Response to Submissions and Amendment Report 2

IRT Woonona Seniors Housing Redevelopment

4-6 Popes Road, Woonona

18 March 2026 | 2250296

Figure 2 Basement Floor Plan (as proposed in RtS and Amendment Report 1)

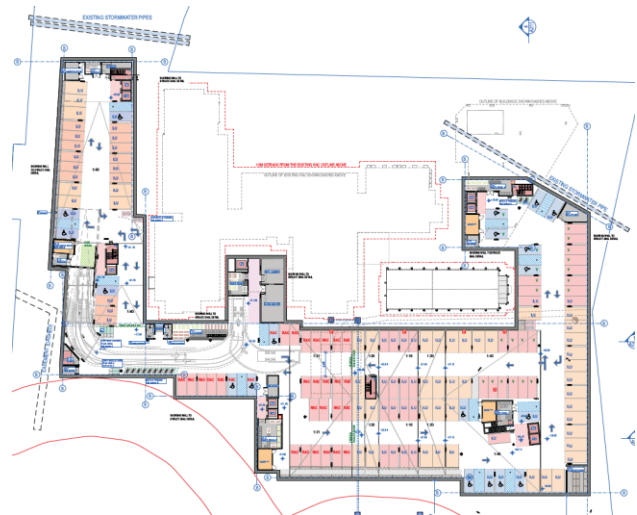
As a result of the reduction in dwellings from 98 (as originally exhibited) to 92 (as amended under RtS and Amendment Report 1), a reduction in the size of the basement car parking area is proposed. A comparison between the two basement designs is provided at **Figure 2** and **Figure 3**. The numerical difference between the basement parking distribution is provided at **Table 1**.

Figure 4 Building D landscape plan (as proposed in previous amendment report)

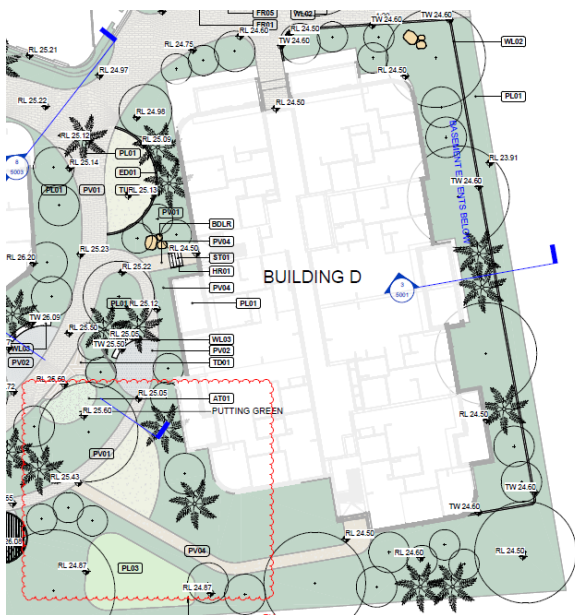
This RtS and Amendment Report 2 proposes to rationalise the landscaping approach to reflect the changes to Building D. A visual comparison of the previous landscape plan and the updated landscape plan, with respect to Building D, is provided at **Figure 4** and **Figure 5** below.

Figure 7 Northern channel landscape plan (as now amended in RtS and Amendment Report 2)

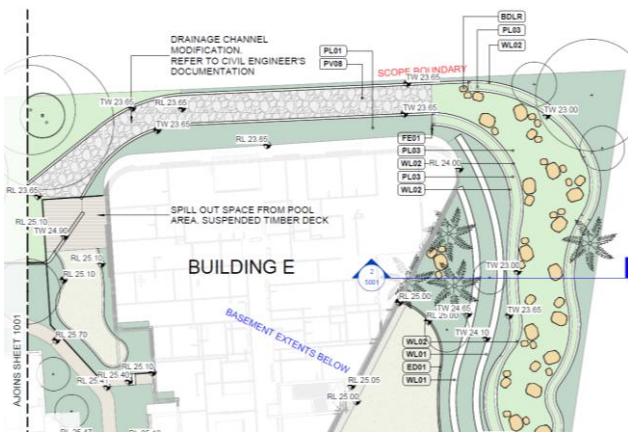
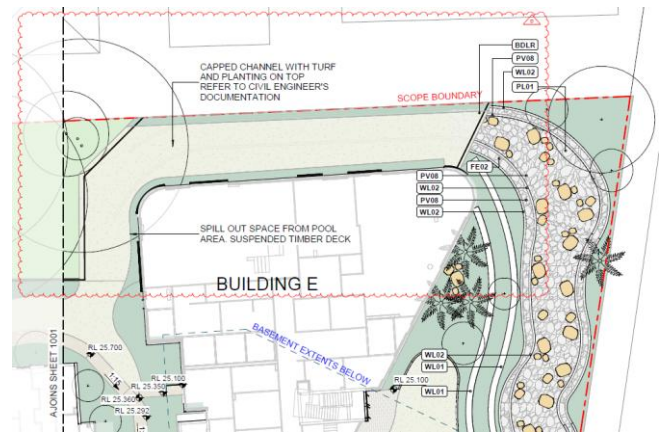
The amended scheme proposes a minor redesign of the drainage channel that runs along the northern boundary of the site, between Building E and the neighbouring property. It is noted that the DPH's RFI letter dated 25 February 2026, a 1.2m pipe was recommended in lieu of the proposed diversion channel. As detailed in the Response Letter prepared by Innovis (**Appendix K**), the proposed 1.2m pipe was not deemed appropriate as it would not have sufficient flow capacity to convey the flows.

The proposed amendment therefore seeks to provide a capped stormwater channel, with turf and planting on top, to provide an improved stormwater and visual outcome for the site. A comparison between the previously amended, and proposed landscape plans is provided at **Figure 6** and **Figure 7**, respectively, alongside a visual representation of the channel, provided at **Figure 8**. Refer to **Appendix D** for the full set of updated Landscape Plans. The detailed sections and visualisation of the drainage channel along the eastern boundary of the site is provided in the RtS and Amendment Report 1 (dated 9 December 2025), at Appendix J and Appendix KK.
